**RESPONSE TO REQUEST FOR FURTHER INFORMATION – WORKS APPROVAL
APPLICATION CATEGORY 58A BULK (DWER REFERENCE: DER2024/000324)**

MARDIE SALT & POTASH PROJECT SALT WASH PLANT AND STOCKYARD FEED PROPOSED ALTERNATIVE RECLAIM CONVEYOR GENERAL ARRANGEMENT			
A1	SCALE 1:2500	PROJECT No MAR178	DRG No 11755-1800-G-SK-002
			REV B

ATTACHMENT 1: UPDATED STOCKYARD PROPOSED GENERAL ARRANGEMENT

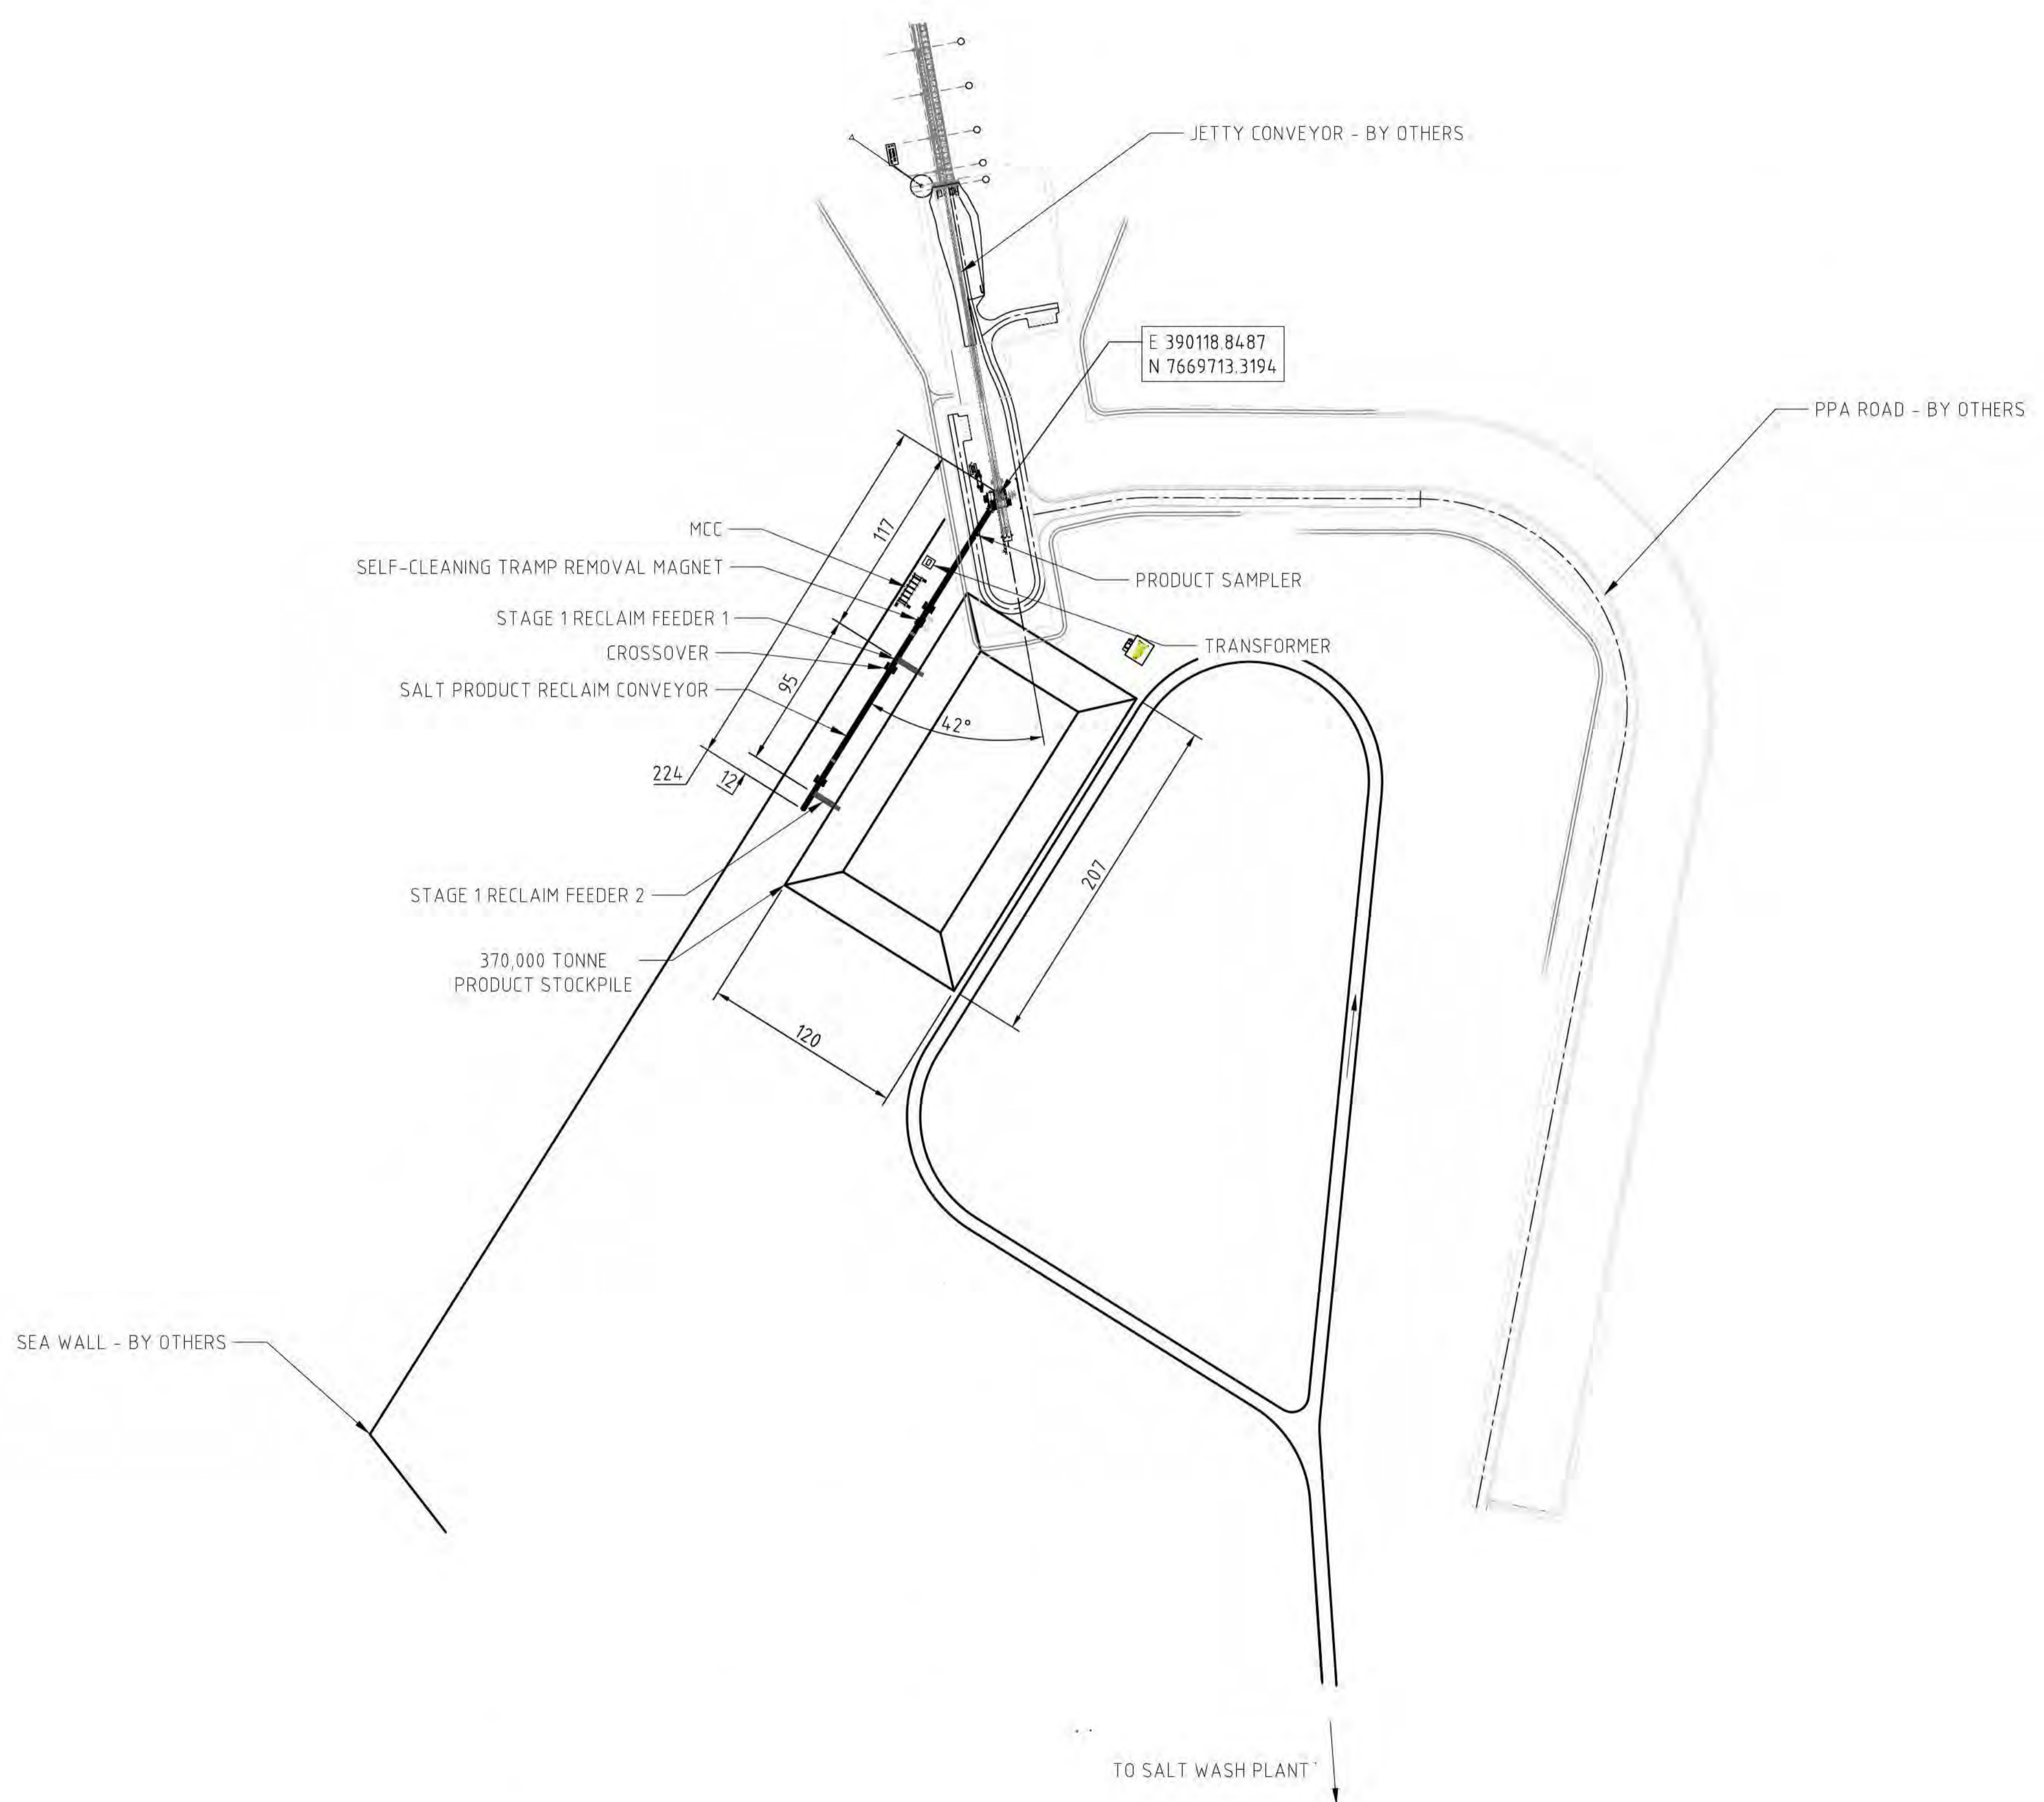
3	<p>Following provision of the above in 1 & 2 above, can you please provide an updated version of Attachment 4 showing all SoP/salt stockpiles, SoP/salt dump stations and any connecting conveyors, stackers, etc.</p>	<p>An updated version of the updated stockyard proposed general arrangement figure is provided in Attachment 1 to show the location of the SoP enclosed shed.</p>
4	<p>W6594/2021/1 authorises processing and storage of SoP within an enclosed system fitted with dust extraction, however, there appears to be minimal dust control infrastructure proposed (e.g. dust extraction, enclosure, etc.) for the transfer of SoP from the enclosed storage shed to the port, and on ship loading equipment.</p>	<p>As noted against item 1a above, the SoP will be direct shipped and will be carted 'just in time' for ship loading from the SoP processing plant to the port. This means the residence time for the SoP within the enclosed shed is very short (i.e. between 5 to 7 days maximum) before it is loaded on the TSV and OGVs.</p>
